13 VICTORIA PARADE
3 STOREY BRICK
MIXED USE BUILDING

PROPOSED S4.55(8) MODIFICATIONS LIST:

ISSUED FOR s4.55(8)
LODGMNT
NOT FOR CONSTRUCTION

| DRAWING TITLE | | PROJECT | |
|------------------|-----------|---------|----------|
| FIRST FLOOR PLAN | | VPM | |

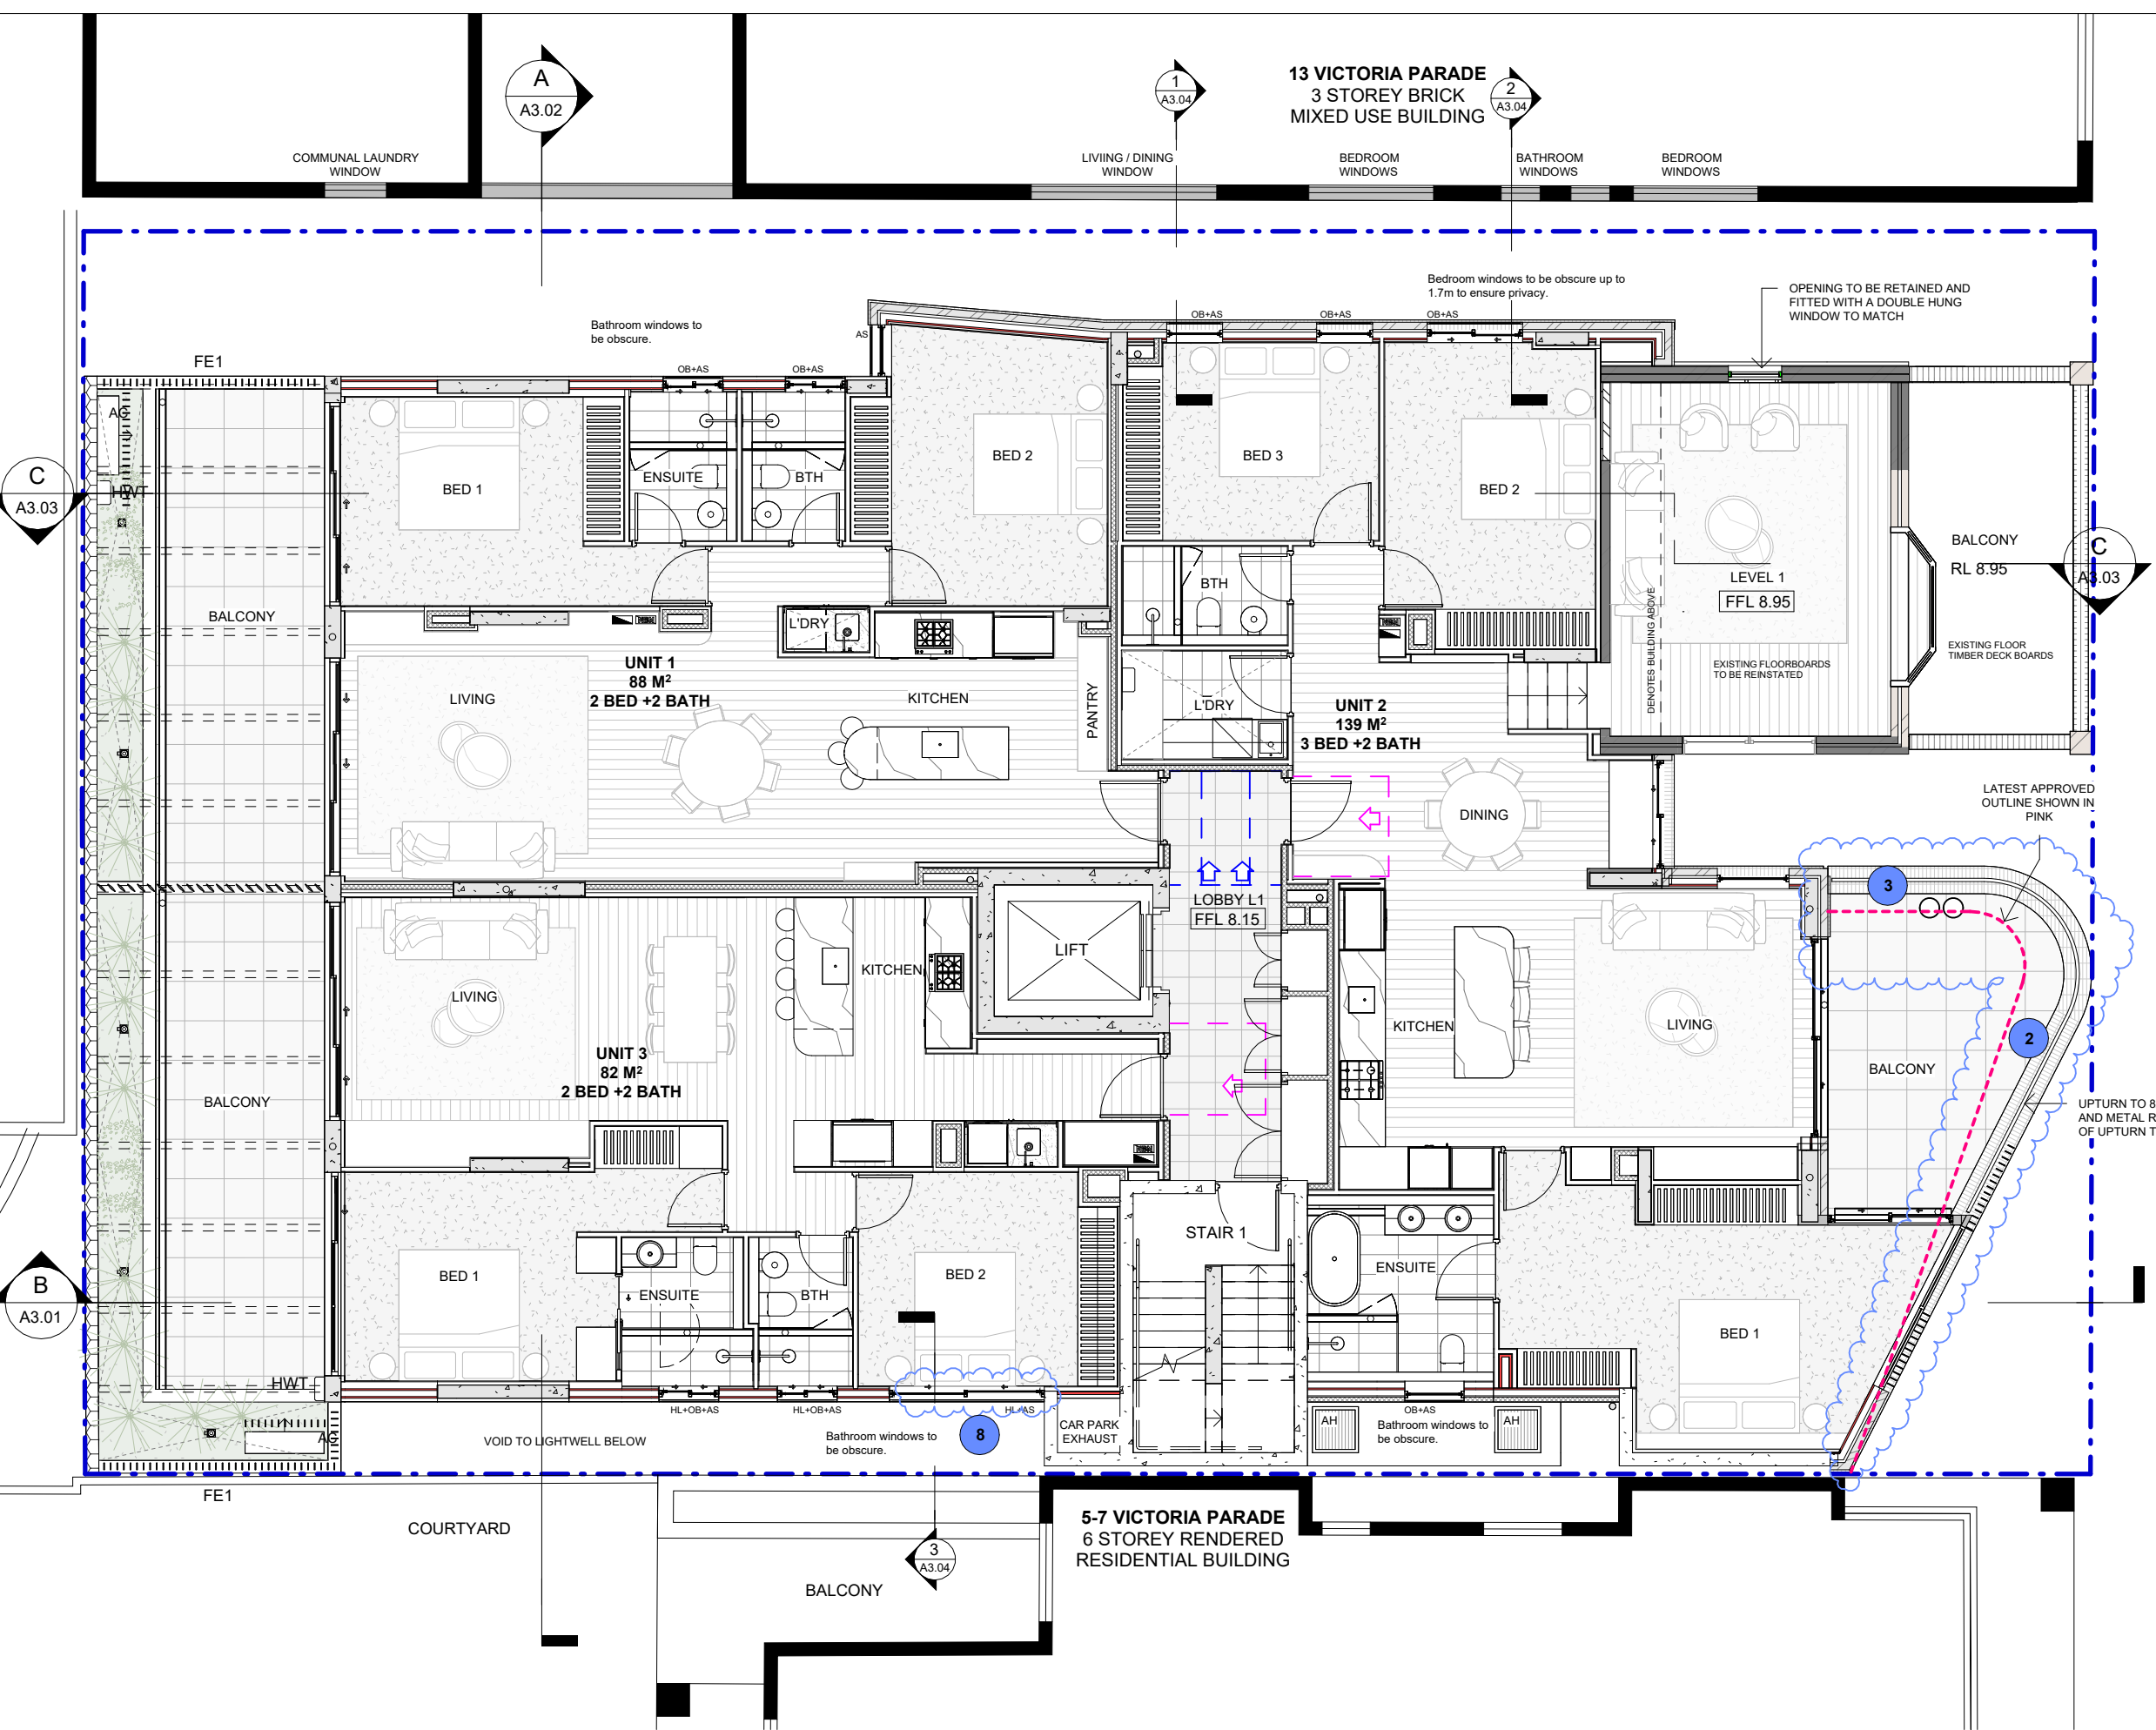
- Retail 1 on Ground floor has been pushed out to enhance the usable area and to suit new columns for balconies above.
- The front facade's angle has been adjusted to enlarge the front balconies and comply with ADG regulations of balcony size.

- Front balconies on level 1 and level 2 were extended to the north east to align with the approved balconies above to avoid looking 'top-heavy' and unbalanced.

- Level 4 brick wall shifted to align with adjacent brick walls.
- Cladding colour proposed to be off-white to visually lighten the bulk of the upper floors.

- Allocation of 1 bicycle space per unit in large storage cages in lieu of separate bicycle parking to satisfy the intention of condition 43D.
- Private roof terrace introduced to improve amenity of unit 14. The glass stair enclosure is not readily visible from the street and has no real impact on privacy, bulk or overshadowing.

- Increase in width of high-light windows to improve ventilation and natural lighting in the bedrooms with no privacy impacts.
- Minor adjustment to the GFA due to the above- still less than LEC approved FSR 3:1.

- Window heads have been lowered to 2.58m to fit services
